**FINAL SAFETY EVALUATION BY  
THE OFFICE OF NEW REACTORS  
(REVISED)**

**Topical Report APR1400-F-A-TR-12004-P  
“Realistic Evaluation Methodology for Large-Break Loss of  
Coolant Accident of the APR1400”**

**Korea Hydro & Nuclear Power Co. Ltd**

Figure 3-1 CAREM Flow Diagram

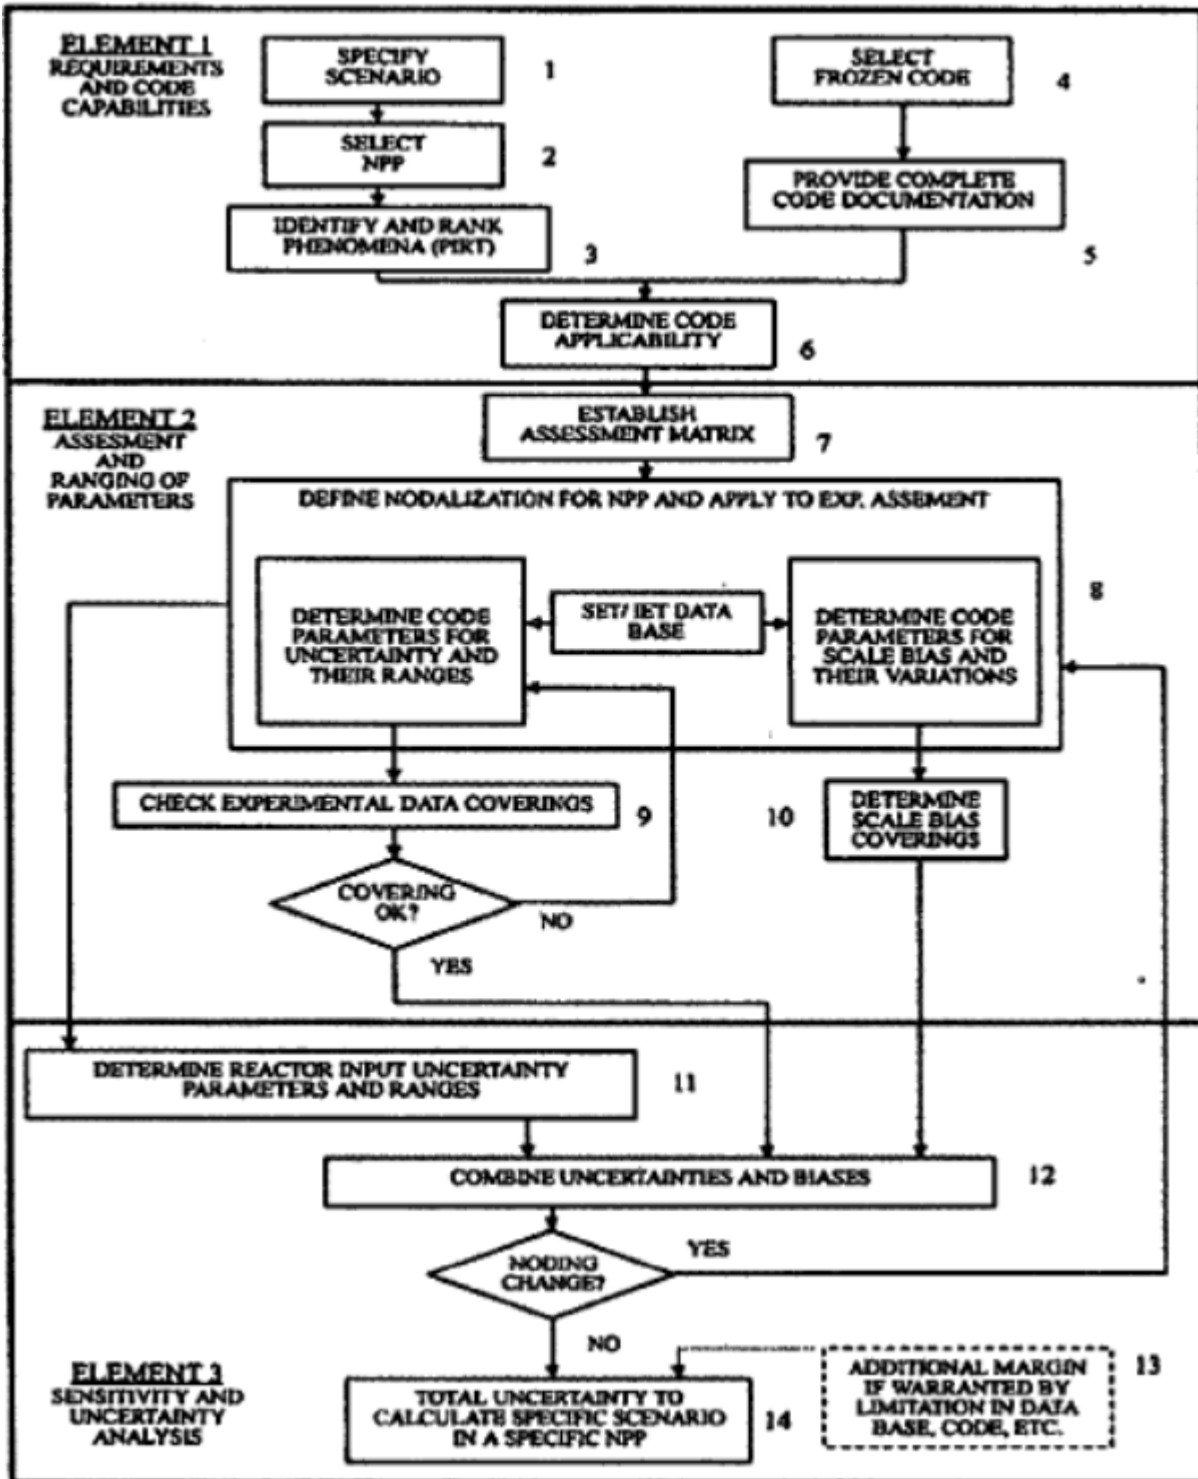
The applicant states in TR Section 1 that the CAREM methodology described in the TR strictly follows the concept and philosophy of CSAU as documented in NUREG/CR-5249. Comparing Figure 1-1 in the TR to Figure 1 of NUREG/CR-5249, the NRC staff noted that the step that determines whether a nodding change is necessary is different between the two figures. In the TR, the determination is made after all the uncertainties and biases have been determined. On the other hand, in NUREG/CR-5249, nodalization is established as part of the second element of the approach (i.e., assessment and ranging of parameters), while biases and uncertainties are determined as part of the third and last element of the process. In AI-4 [Ref. 3], the NRC staff requested the applicant to explain this discrepancy. During the January 2016 Audit Meeting, KHNP provided a presentation on the CAREM process [Ref. 27] describing how and when nodding changes occur, stating that prior practice established the original nodalization, which was based upon separate effects tests. KHNP stated [Ref. 4] that they would revise the nodding and repeat all of the process steps if changes were warranted to simulate test results or to capture important phenomena. This approach, although not strictly the same as that outlined in the CSAU (NUREG/CR-5249), is considered reasonable, since it provides a mechanism to revise the nodalization if important phenomena could not be captured.
